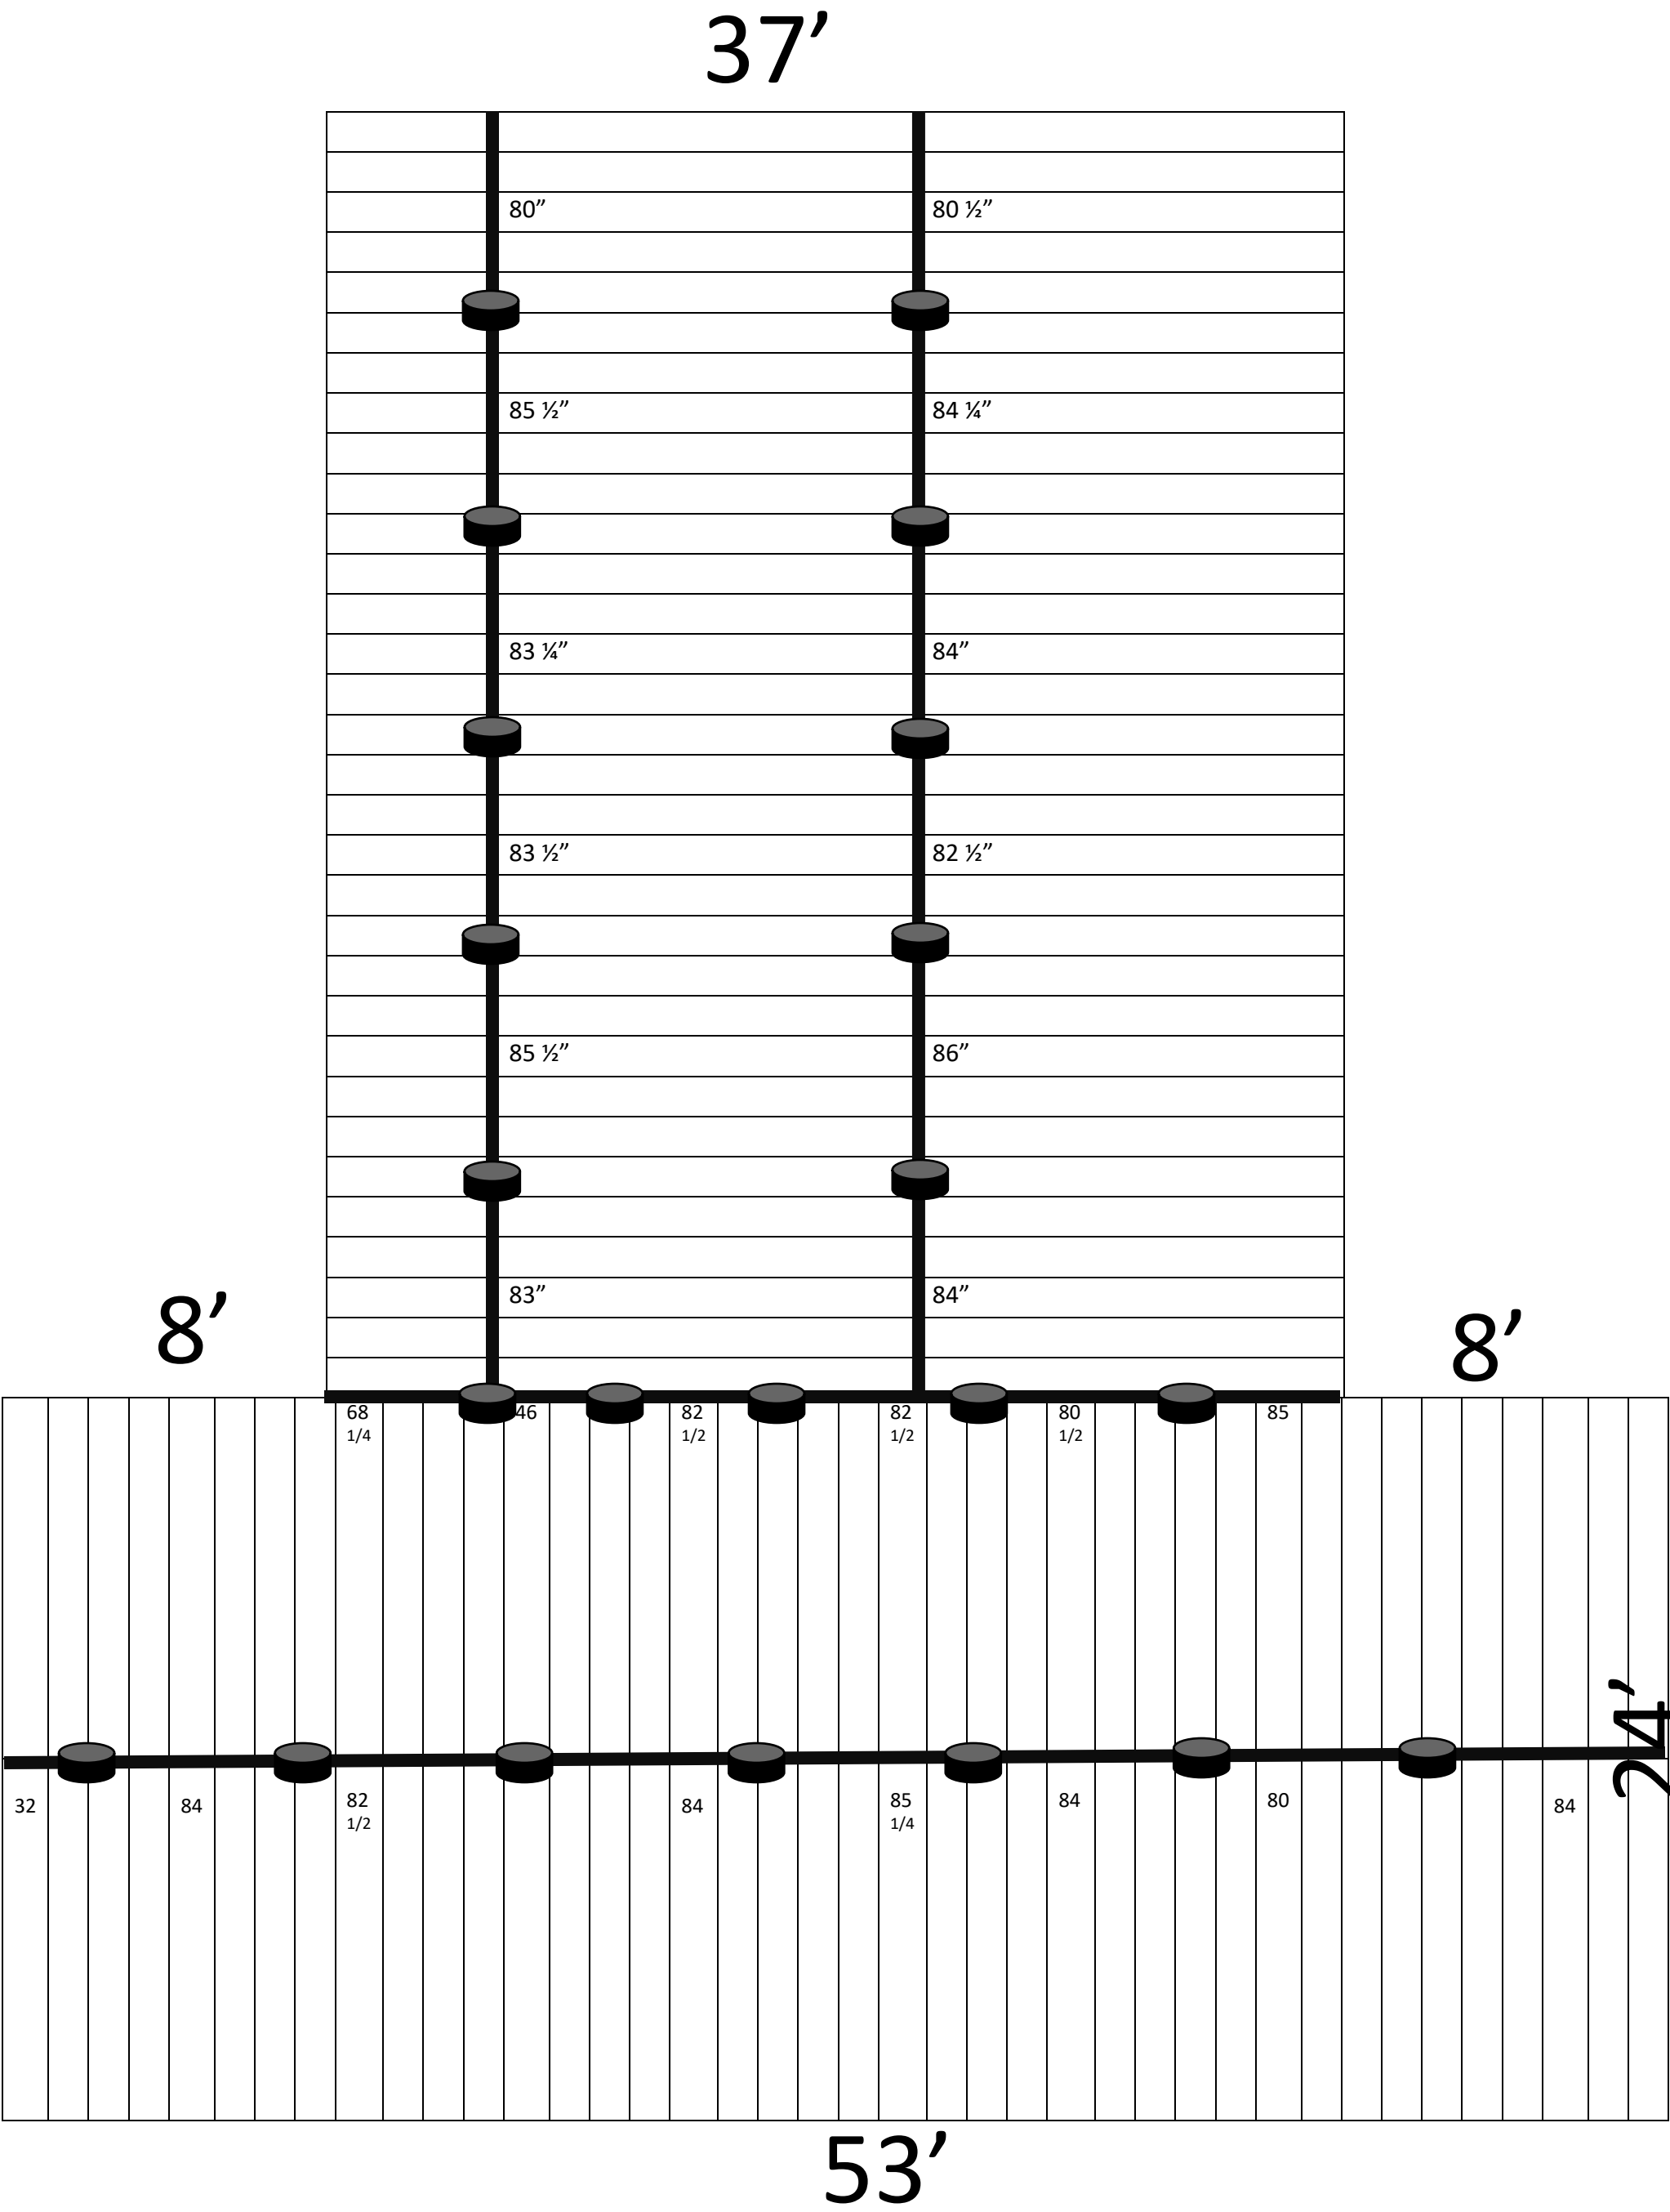
JOISTS ARE 2X10 AND LAYOUT DOES NOT ACCURATELY SHOW, THEY ALTERNATE AND OVERLAP AT BEAM.

PROJECTED BEAMS ARE ALL 2 PLY 1 3/4 X 11 7/8 1.9 LVL FOR A TOTAL OF 3.5" X 11 7/8 1.9 LVL
